5.5. OPERATIONAL WORK REMOVE TREES 11 TI TREE ST PT DOUGLAS

PROPOSAL Operational Works (Vegetation Damage) for tree removal

LOCATION OF SITE 11 Ti-Tree Street Port Douglas

TREE HEALTH AND CONDITION REPORT 20 September 2017

Site plan of 11 Ti Tree Street, Port Douglas.

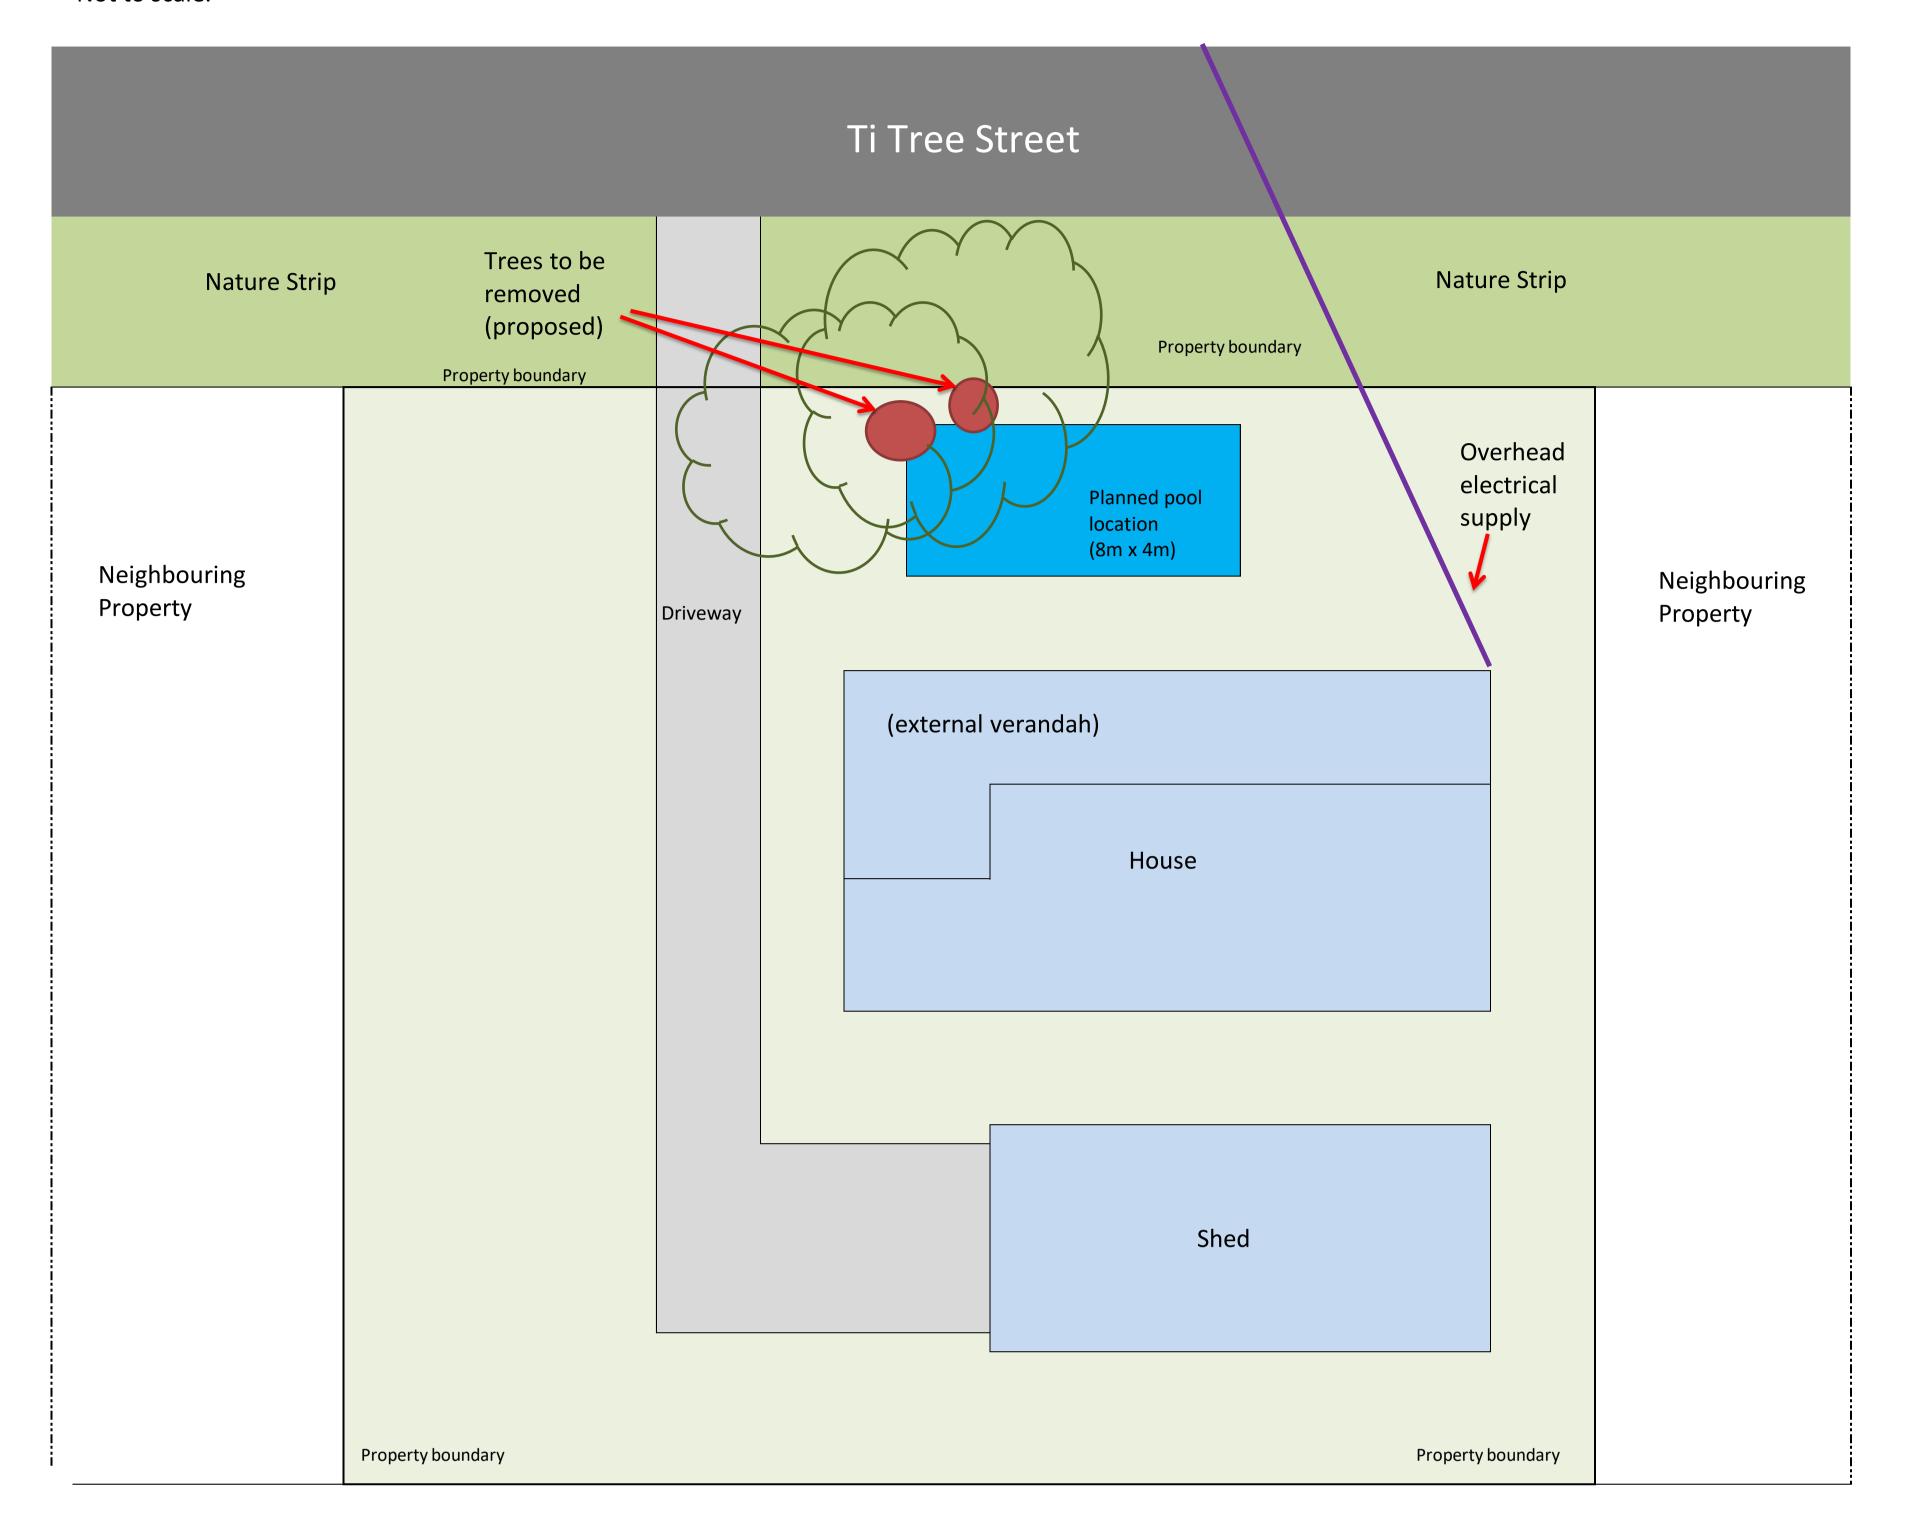
- 2. The application for a Development Permit must be accompanied by amended plans that detail:
 - a. The detail and particular location of the swimming pool and associated pool fencing;
 - b. Landscaping in lieu of the removed significant trees having regard to the requirements for swimming pool fencing and overhead power lines connecting the house. All landscaping must be on the land.

The applicant has advised of an intention to construct a swimming pool in the front yard of 8m x 4m immediately adjacent to the two trees. To date, no development permit for building work has been applied for or approved for the swimming pool.

The arborist report accompanying the application states that the integrity of the trees will be compromised by the excavation for the swimming pool. The trees are not compliant having regard to the distance to the proposed swimming pool fence.

Drawing or Document	Reference	Date
Site Plan	Generally as submitted with application on 5 September 2017 Council document 826336 and as amended by Condition 3.	5 September 2017

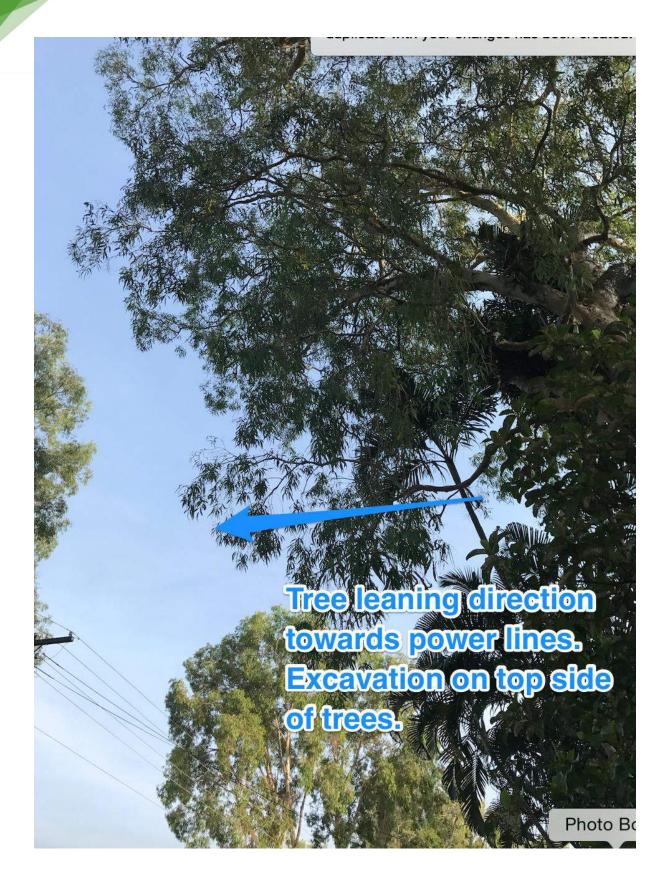
Comments	Recommendations	Priority
Tree is located within feet of proposed	Removal and stump grind.	Н
excavations for pool and is too close to pool	The trees Integrity is going to be	
fencing for compliance. Much of the pool area	compromised by the excavation of	
will be within current dripline of tree. The	pool. Also, with the pegged potential	
construction is on the top side of the trees lean	fence, its hard to see how it would be	
which mean the excavation will cause damage	complaint with trees within metre of	
to the tree root system and its integrity.	fence.

Comments	Recommendations	Priority
Similar to tree 13, Tree is located within feet of	Removal & stump grind	Н
proposed excavations for pool and is too close to	The trees Integrity is going to be	
pool fencing for compliance. Much of the pool	compromised by the excavation of	
area will be within current dripline of tree. The	pool. Also, with the pegged potential	
construction is on the top side of the trees lean	fence, its hard to see how it would be	
which mean the excavation will cause damage to	complaint with trees within metre of	
the tree root system and its integrity	fence.
